Access Compliance Report Public Rights-of-Way (Curb Ramps)

Main Street: BENJAMIN_DR Cross Street: THORNHILL_ST Location: S

ADA ID: RPRK211115134110 Ramp Type: Type 1 - Perpendicular Diagonal Initial Pass/Fail: Fail Overall Compliance: No Severity Score: 45

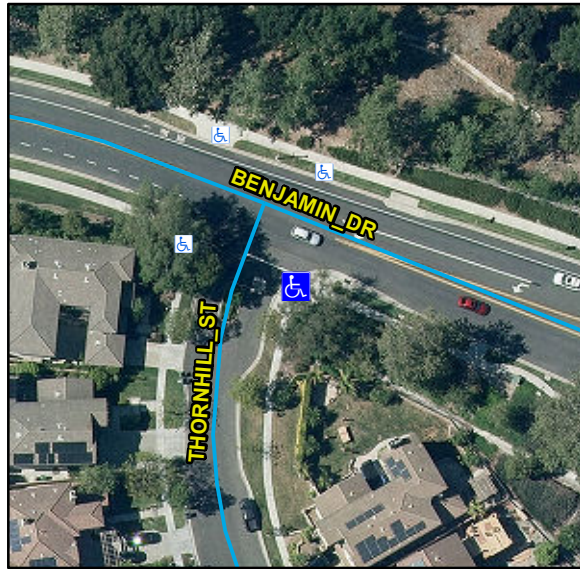
Compliance	Description	Data	Compliance	Description	Data
N/A	Ramp Length (in)	138	N/A	Flare Type LT	
Yes	Ramp Width (in)	48			N/A
No	Ramp Run Slope (%)	9.6	N/A	Flare Slope LT (%)	N/A
No	Ramp Cross Slope (%)	10.1	N/A	Flare Traversable LT	N/A
N/A	Landing Present	N/A	N/A	Flare Type RT	
N/A	Landing Length (in)	N/A			N/A
N/A	Landing Width (in)	N/A	N/A	Flare Slope RT (%)	N/A
N/A	Landing Run Slope (%)	N/A	N/A	Flare Traversable RT	N/A
N/A	Landing Cross Slope (%)	N/A	N/A	DWS Provided	N/A
N/A	Landing Movement Obstructed?	N/A	N/A	DWS Contrast	N/A
	Landing Movement Type	N/A	N/A	DWS Length (in)	N/A
N/A	Landing Shared	N/A	N/A	DWS Full Width	N/A
N/A	Clear Space	Yes	N/A	DWS Offset Left (in)	N/A
N/A	Clear Space To Crosswalk (in)	N/A	N/A	DWS Offset Right (in)	N/A
N/A	Marked Crosswalk 1	No	N/A	Marked Crosswalk 2	No
	Crossing 1 Direction	NE		Crossing 2 Direction	NW
	Marked Crosswalk 1 Width (in)	N/A		Marked Crosswalk 2 Width (in)	N/A

Remove & Replace Curb Ramp With Two New Directional Ramps or Equivalent.
